VESSEL'S NAME Steel T.S.S. "Mooltan" Rpt. Bel No. 8970

The remarks of the Chief Ship Surveyor are desired on this case for the consideration of the Classing Committee.

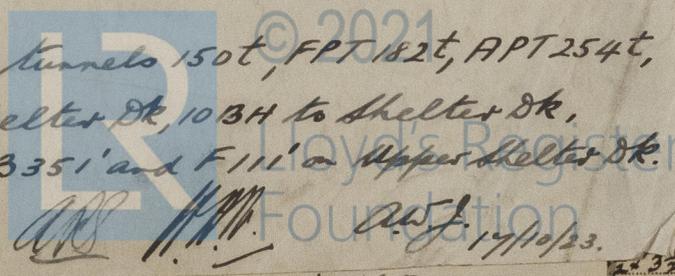
Transverse No. 108.67 Depth "d" 20.74'
 Framing: Table No. 2 Description Angle bar frame and reverse frame as approved.
 Longitudinal No. 65202
 Proportions Length = 11.39
 Depth =

Bridge Deck Sheerstrake as approved.
